ADDENDUM NO. 001

NEW PAVILION AND SPLASH PAD - Project No. 202225751.001A

NEW AMPHITHEATER - Project No. 20231048.001A

Village of Covington

TYPICAL RETAINING WALL DETAIL

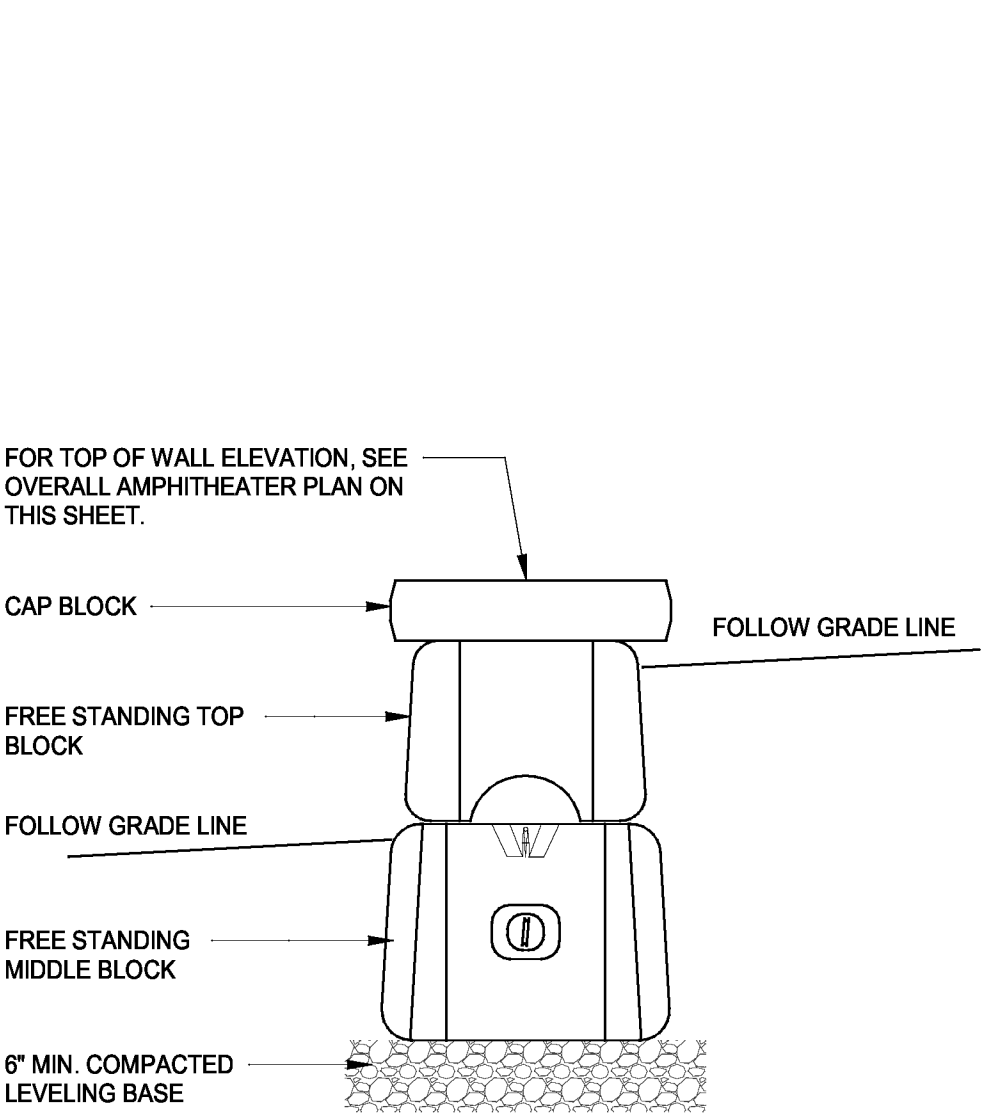
Please provide cost (Add/Deduct) associated with the installation of manufactured retaining block wall and seating in lieu of split-face concrete block as detailed in the attached document.

Question: Please describe the height of the retaining walls. Do they vary?

NOTE:
BASIS OF DESIGN: REDIROCK
ALL BLOCKS SHALL BE REDI-ROCK W/ COBBLESTONE FINISH
- SUPPLIER TO PROVIDE DETAILS WHERE WALLS STEP AND/OR TERMINATE

Response: Yes retaining walls details respond to the site grading and elevations and vary. Guardrails to be installed similar to the Alternate #1 detail issued within this addendum.
